Technical Service Bulletin

TSB00716
Clutch Nut Belleville on CX50's

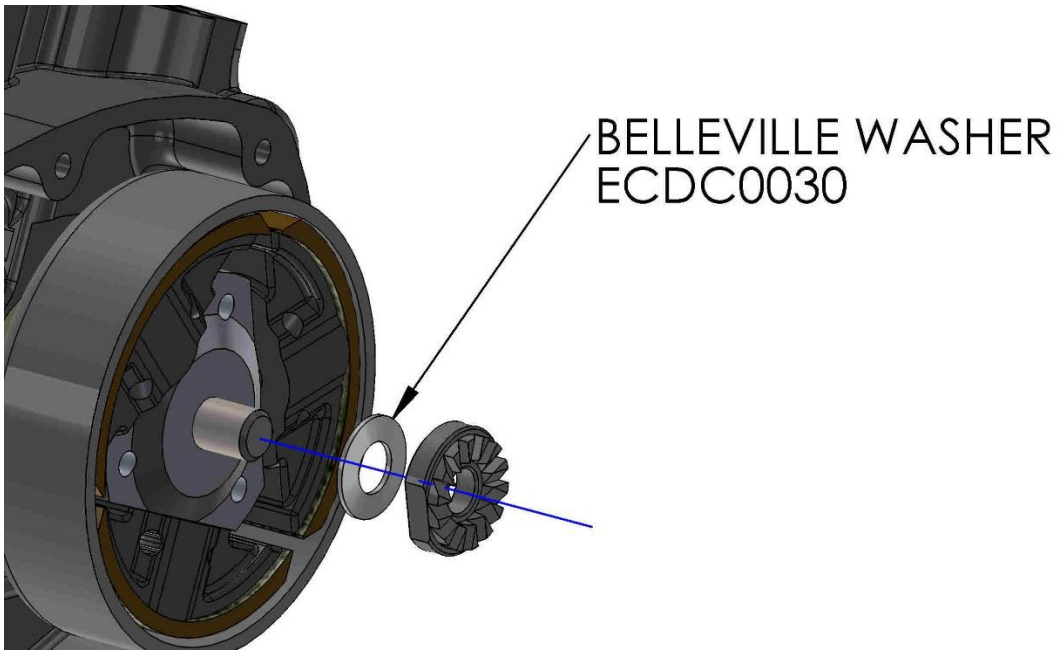
Cobra will begin installing a Belleville lock washer between the clutch arbor and the clutch nut (kick start nut) on the CX50 King and JR models.

It is recommended that the customers install this also.

ECDC0030 is the part number.

As before, torque the clutch nut to 45 ft-lb with red high strength thread lock agent (Loctite 263).
